**TOOELE ARMY DEPOT
INDEPENDENT TECHNICAL REVIEW**

**FINAL RECOMMENDATIONS
REPORT**

MAY 2001

TNT Washout Facility Remediation Flow Chart.....	23
--	----

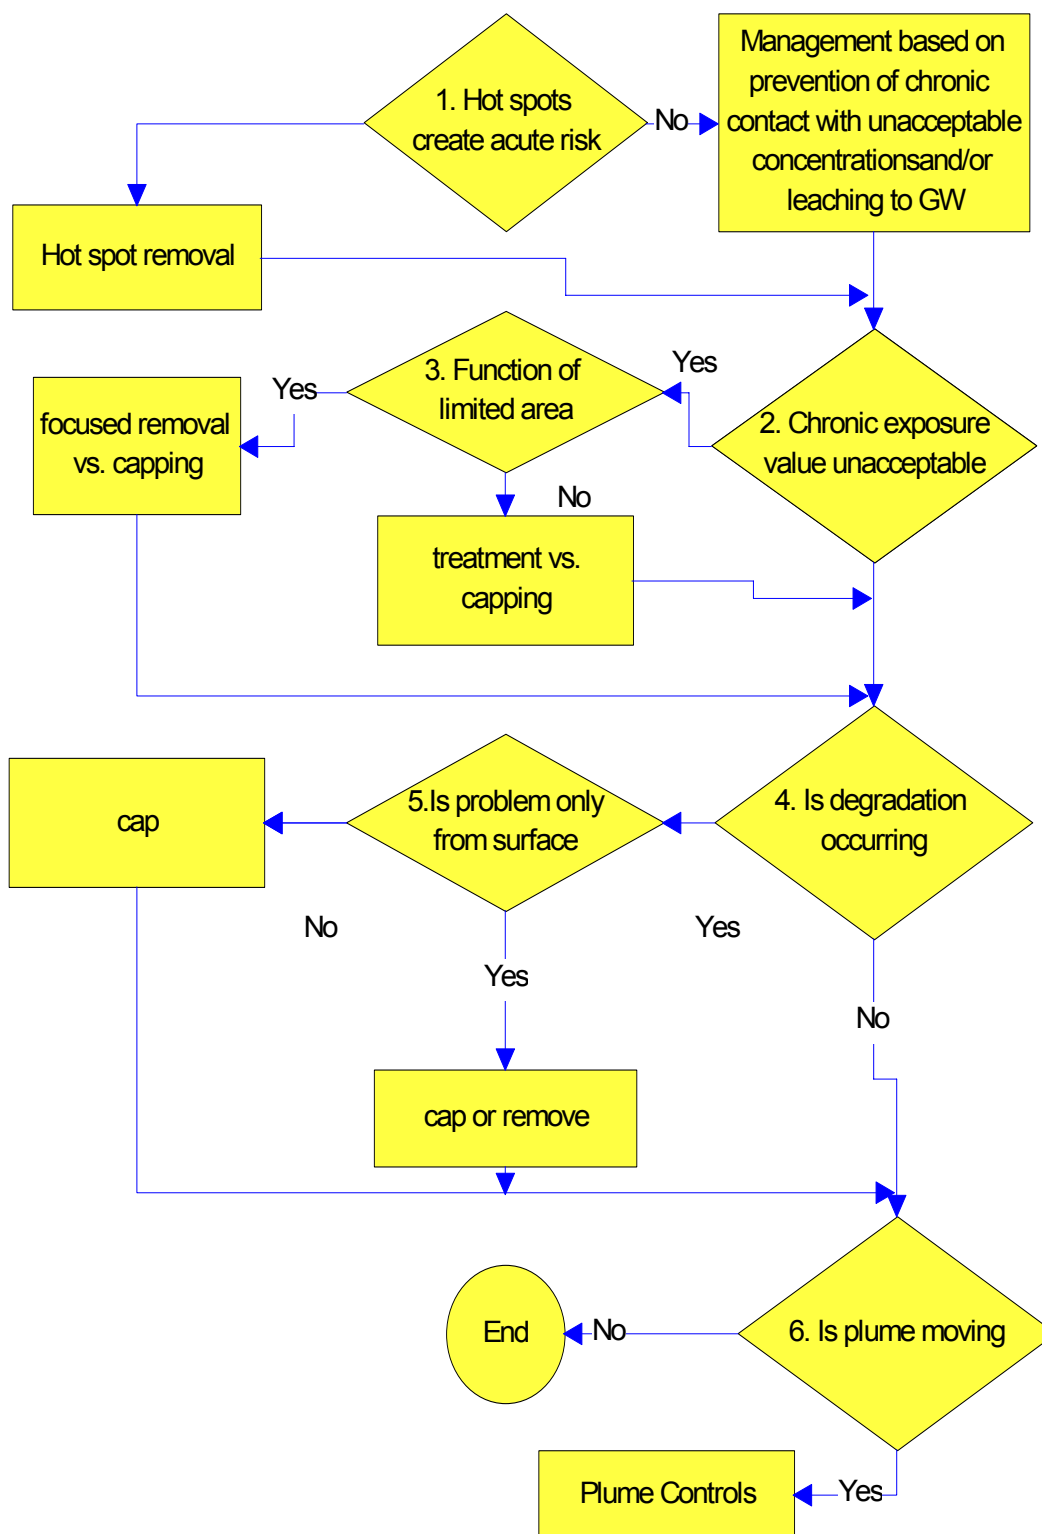
A remediation flow chart of the decision process for the TNT Washout Facility is provided on the following page.
